To all Lamborghini Dealers and Authorised Service Points
From After Sales Service
Pages 1+2
Object Technical Bulletin ref.:CT.03.04
Service 2500 km (Coupon A) or 12000 km-
Lamborghini Gallardo L140
Group 140.00.00.00.04.AditionalCheck2.GB
Date 31.05.2004

Automobili
Lamborghini S.p.A.

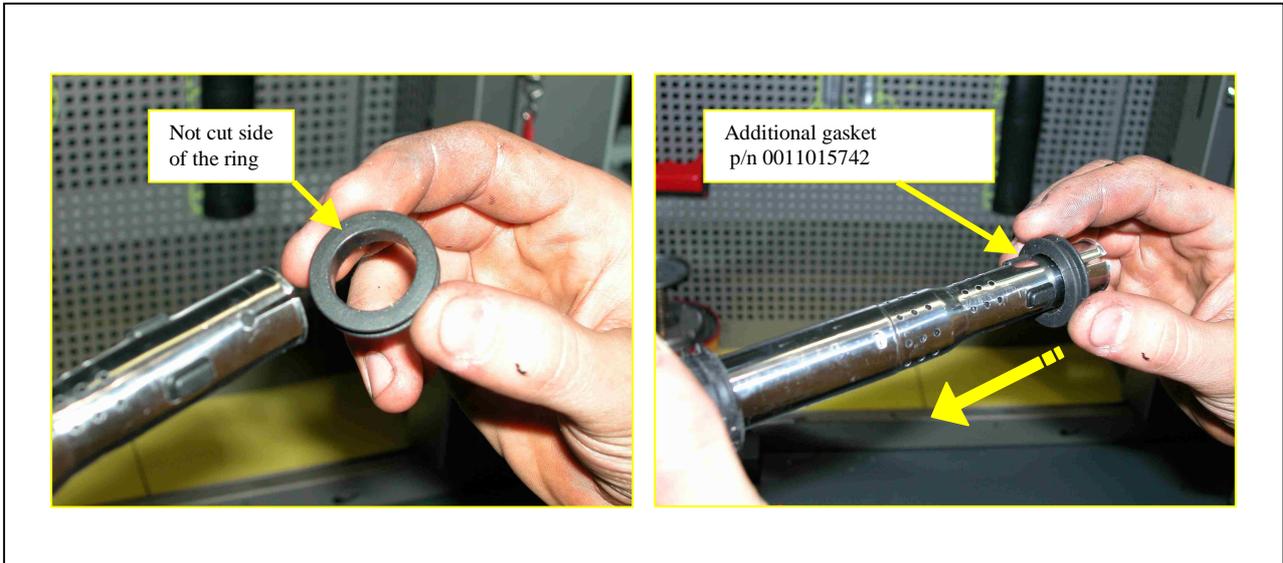
ATTENTION: The correct ignition coil fitting can be verified by checking the measure as shown in picture d.

Picture (a)

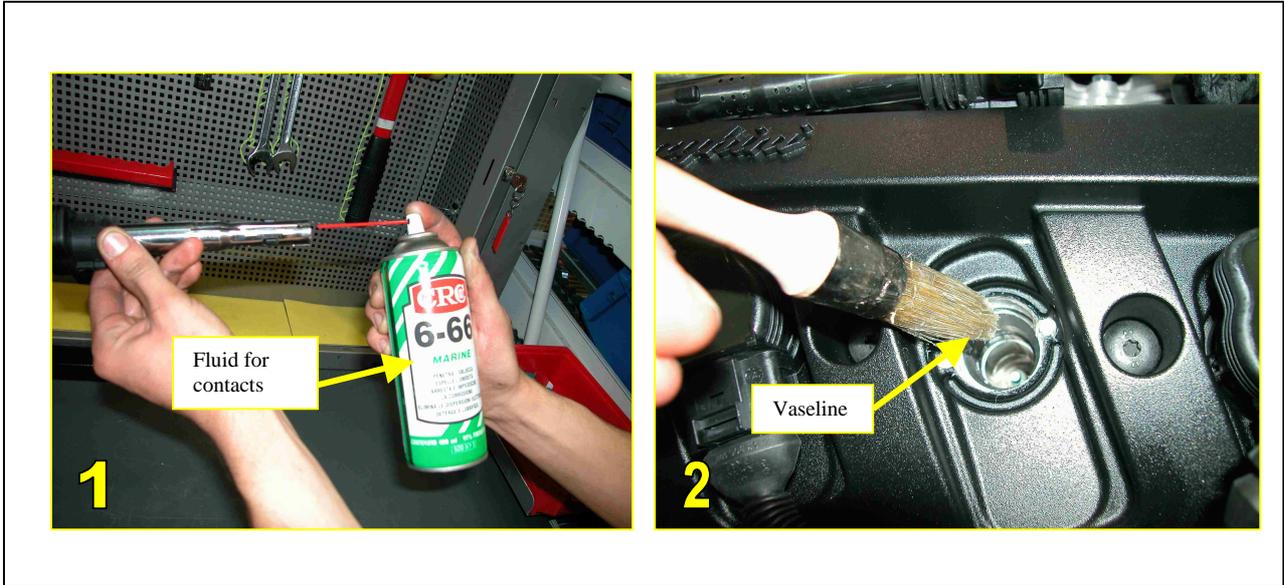
1. Remove the ignition coil
2. Check that ignition coil is in good order (and not supplied with an additional ring)
3. Fit the additional gasket p/n 0011015742 as shown on picture (a)
4. The gasket has a cut surface, this side must be downfaced towards the coil (see note on picture a)
5. Push the gasket, making sure it is perfectly close-fit (figure a)
6. Spray the special fluid for the cleaning of electrical contacts as shown in picture (b-1). We suggest you to use CRC 6-66 Lamborghini code 008970129.
7. Lubricate with vaseline the ignition coil housing (figure b-2)
8. Reassemble the ignition coil making sure it is properly fit in its housing as shown in picture c-1 and c-2.
